Jericho Wind, Inc.

## **Revision to the Water Assessment and Water Body Report – Jericho Wind Energy Centre**

60301207

September, 2013

Figure 2-1A

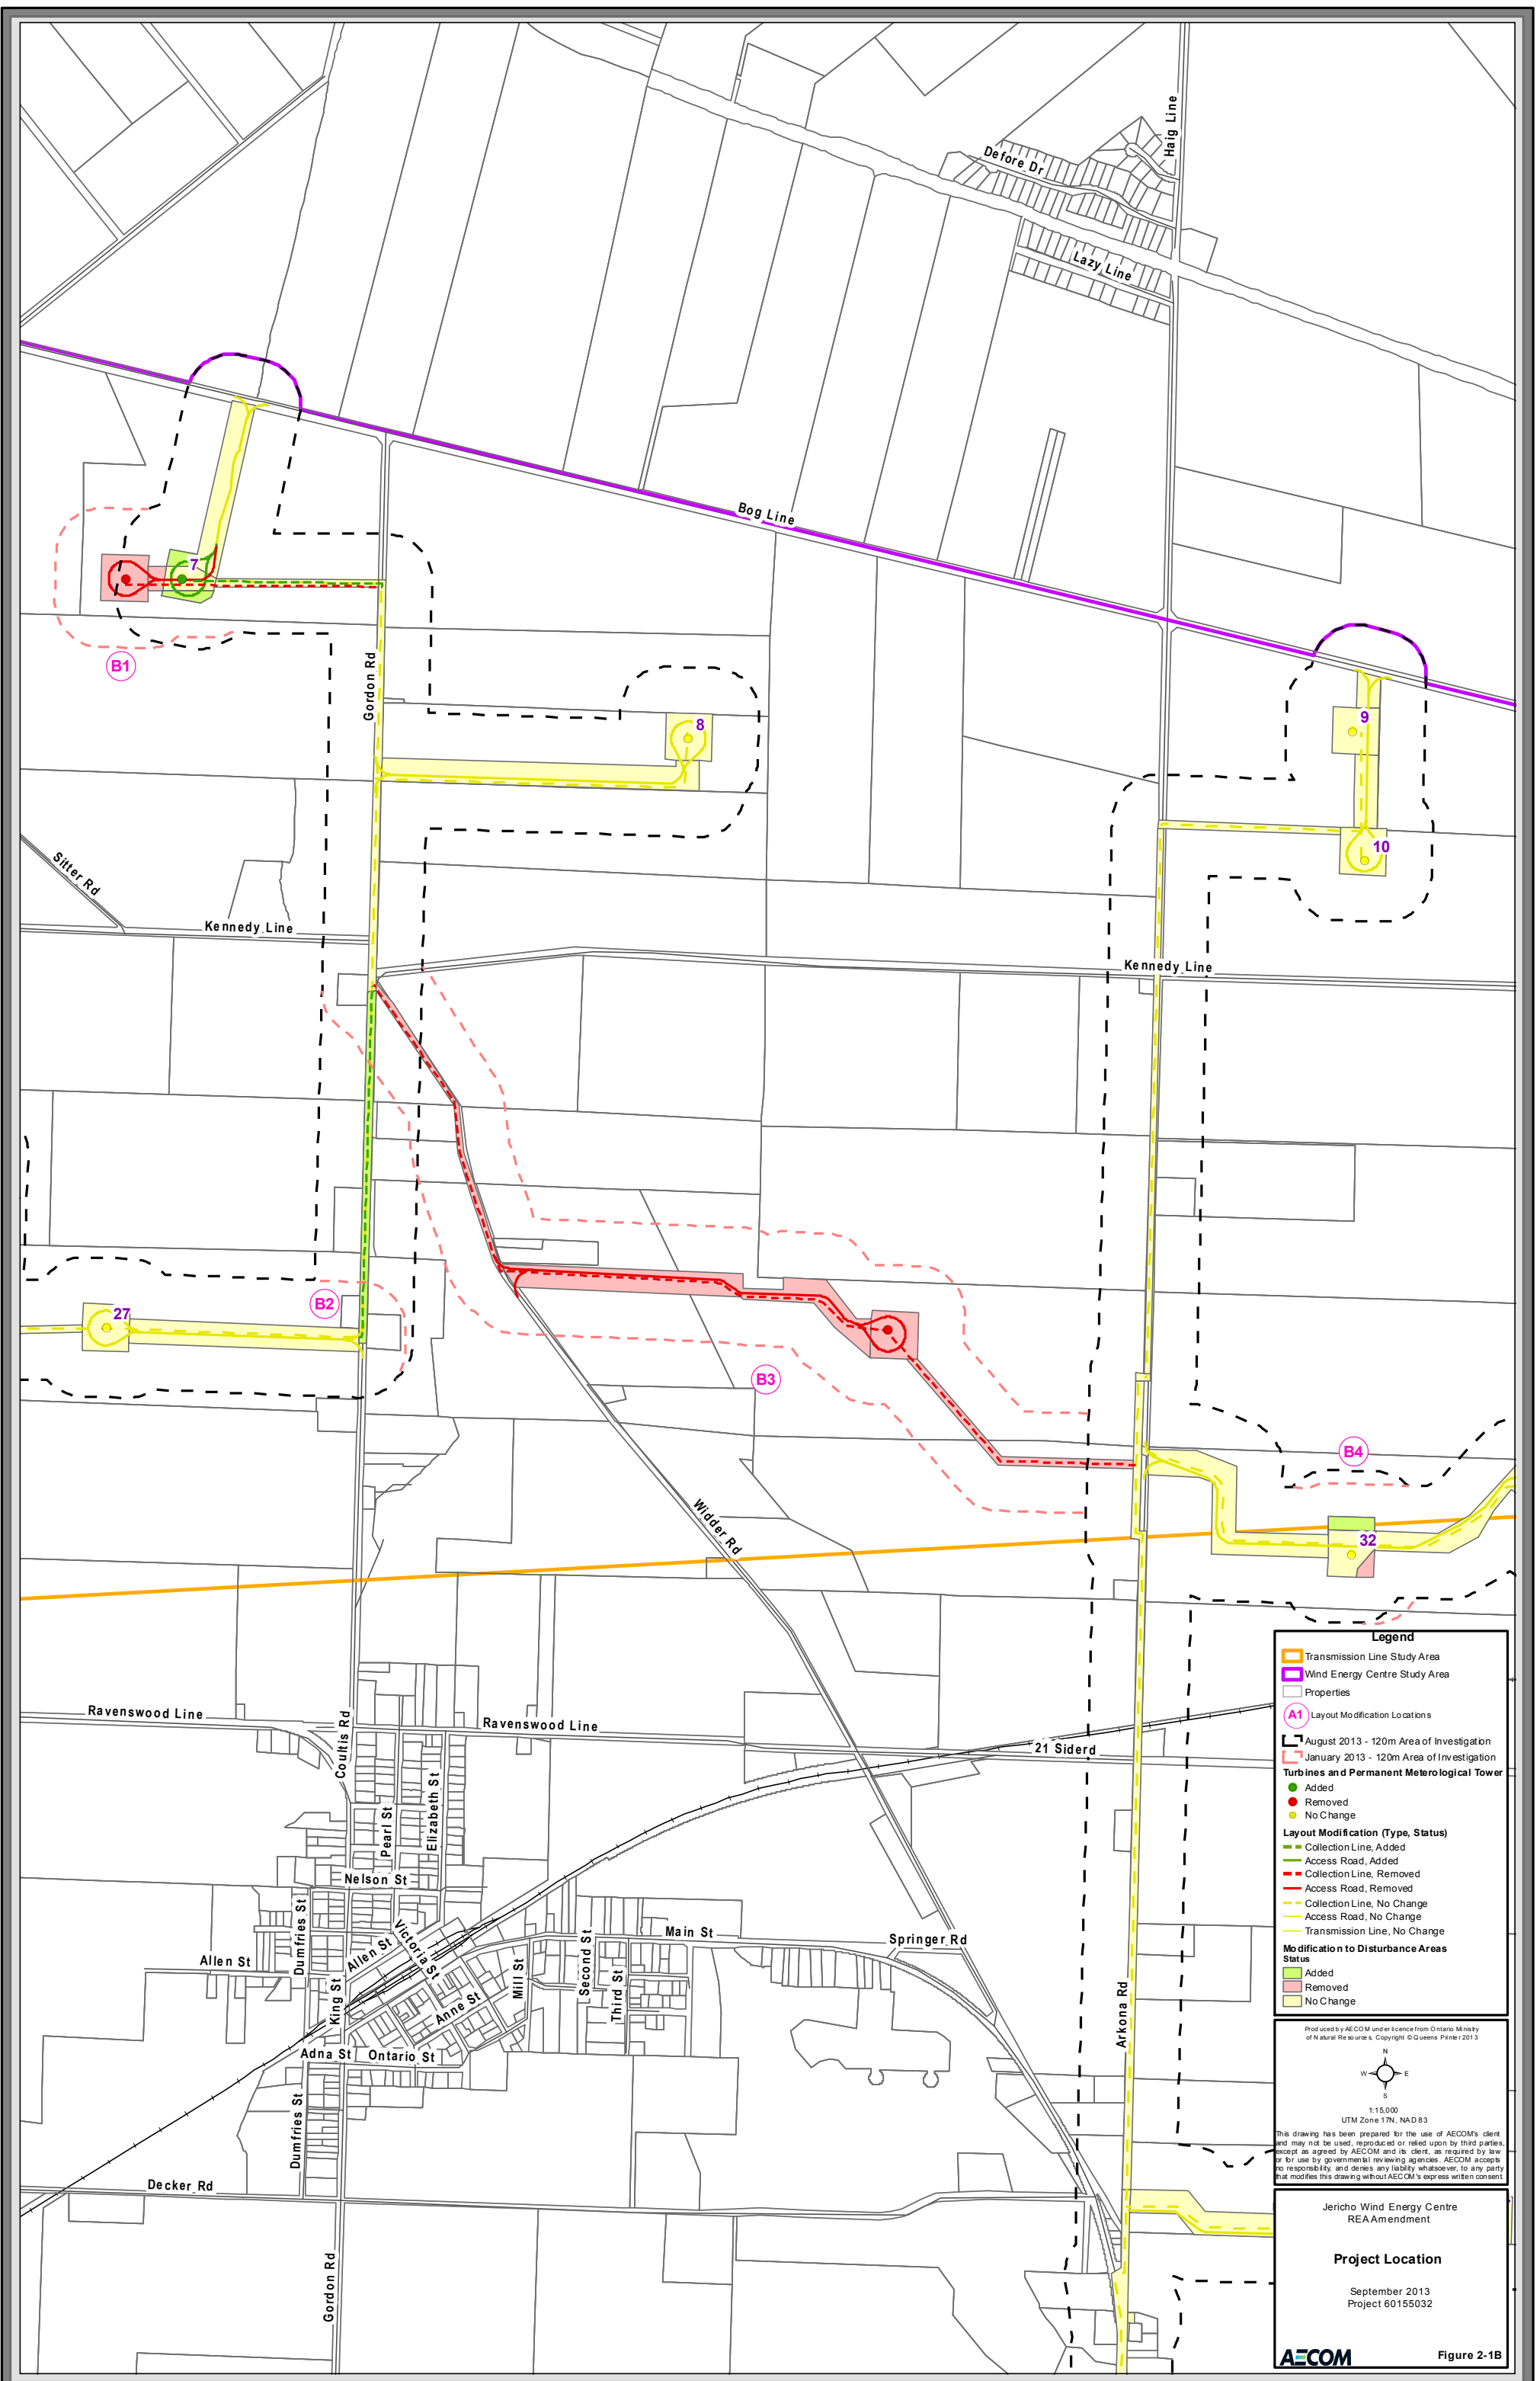
Label on Figure 2-1	Proposed Modification	Rationale for Proposed Modification	New Potential Environmental Effects <i>(related to Water Bodies)</i>	New Mitigation Measures <i>(related to Water Bodies)<sup>1</sup></i>
A1	Addition of Turbine 106 and associated access road and collection line, extending northeast from Turbine 4.	Infrastructure or construction disturbance area added or changed to optimize project design/ constructability.	<p>Water body present within 120 m buffer of turbine and infrastructure (Feature ID R4.16-D).</p> <p><b>Turbine</b></p> <ul style="list-style-type: none"> <li>• Increase to surface water temperature from reduced groundwater contribution if dewatering activities are required for excavation of turbine foundations.</li> <li>• Increase to streamflows in watercourses that receive temporary groundwater dewatering discharge (if required). Groundwater discharge has potential to cause streambed and/or bank erosion and downstream sedimentation if not managed properly.</li> <li>• Increased erosion, sedimentation and turbidity in watercourse from clearing and grubbing on adjacent lands for construction of turbine, pad and turnaround area.</li> <li>• Soil compaction, which may result in hardening of surfaces and increased runoff into watercourses.</li> <li>• Release / discharge of runoff from the construction area, which has the potential to transport sediment and nutrients into the watercourse.</li> <li>• Soil/water contamination by oils, grease and other materials from accidental spills and release of contaminants from construction equipment.</li> <li>• Increase in impervious surfaces from presence of turbine foundation, resulting in increased water temperatures, increased surface runoff and stream peak flows, and reduced infiltration, base flows and upwelling.</li> </ul> <p><b>Access Road</b></p> <ul style="list-style-type: none"> <li>• Increased erosion, sedimentation and turbidity from clearing and grubbing for construction of access roads.</li> <li>• Soil/water contamination by oils, grease and other materials from construction equipment.</li> <li>• Release / discharge of runoff from the construction area, which has the potential to transport sediment and nutrients into the watercourse.</li> <li>• Reduction of streamflow due to the withdrawal of surface water for construction activities such as dust suppression, equipment washing and land reclamation (e.g., hydroseeding).</li> <li>• Increase in impervious surfaces from presence of access road, resulting in increased water temperatures, increased surface runoff and stream peak flows, and reduced infiltration, base flows and upwelling.</li> </ul> <p><b>Collection Line</b></p> <ul style="list-style-type: none"> <li>• Soil / water contamination by oils, gasoline, grease and other materials from accidental spills and release of contaminants from equipment.</li> <li>• Release / discharge of runoff from the construction area, which has the potential to transport sediment and nutrients into the watercourse.</li> </ul>	<p><b>Turbine</b></p> <ul style="list-style-type: none"> <li>• Timing windows</li> <li>• Erosion and sediment control</li> <li>• Grading and excavation</li> <li>• Material stockpiling and handling</li> </ul> <p><b>Access Road</b></p> <ul style="list-style-type: none"> <li>• Timing Windows</li> <li>• Erosion and sediment control</li> <li>• Grading and excavation</li> <li>• Equipment use</li> <li>• Material stockpiling and handling</li> </ul> <p><b>Collection Line</b></p> <ul style="list-style-type: none"> <li>• Equipment use</li> <li>• Erosion and sediment control</li> </ul>

A2	Relocation of access road to Turbine 4 to travel northeast from Jericho Road, and relocation of collection line to Turbine 4 near Kennedy Line.	Construction disturbance area modified to reduce or eliminate impacts to archaeological resources.	No new effects identified.	n/a
A3	Relocation of access road and collection line to Turbine 6 to travel west from Northville Road and then north to Turbine 6; relocation of Turbine 6 construction disturbance area to the north.	Construction disturbance area modified to reduce or eliminate impacts to archaeological resources.	None – no water bodies identified in the new 120 m infrastructure buffer.	n/a
A4	Relocation of Turbine 19 construction disturbance area 19 m to the southwest and addition of access road construction disturbance area near Jericho Road.	Construction disturbance area modified to reduce or eliminate impacts to archaeological resources.	No new effects identified.	n/a

A5	Removal of access road and collection line to Turbine 24, addition of access road disturbance area between Turbine 22 and Turbine 24 and relocation of collection line to the access road disturbance area for Turbine 22.	Infrastructure or construction disturbance area added or changed to optimize project design/ constructability.	<p>2 road crossings on the water body instead of 1(Feature ID R4.33-B). The potential environmental effects on the water body present in 120 m buffer and new access road crossing are listed below.</p> <p><b>Access Road</b></p> <ul style="list-style-type: none"> <li>• Obstruction of lateral flows in watercourses from water crossings.</li> <li>• Temporary disruption of substrates/habitat at locations where in-water work is required (culvert installations).</li> <li>• Degradation of fish habitat from culvert installation.</li> <li>• Increased erosion, sedimentation and turbidity from clearing and grubbing for construction of access roads.</li> <li>• Soil/water contamination by oils, grease and other materials from construction equipment.</li> <li>• Release / discharge of runoff from the construction area, which has the potential to transport sediment and nutrients into the watercourse.</li> <li>• Reduction of streamflow due to the withdrawal of surface water for construction activities such as dust suppression, equipment washing and land reclamation (e.g., hydroseeding).</li> <li>• Increase in impervious surfaces from presence of access road, resulting in increased water temperatures, increased surface runoff and stream peak flows, and reduced infiltration, base flows and upwelling.</li> <li>• Soil/water contamination by oils, grease and other materials from maintenance activities.</li> <li>• Obstruction of lateral flows in watercourses and other water bodies due to design of culverts and debris build-up at water crossings.</li> </ul>	<p><b>Access Road</b></p> <ul style="list-style-type: none"> <li>• Culvert Design</li> <li>• Isolated crossing</li> <li>• Timing Windows</li> <li>• Erosion and sediment control</li> <li>• Grading and excavation</li> <li>• Equipment use</li> <li>• Material stockpiling and handling</li> <li>• Water quality</li> <li>• Water management</li> <li>• Rehabilitation</li> </ul>
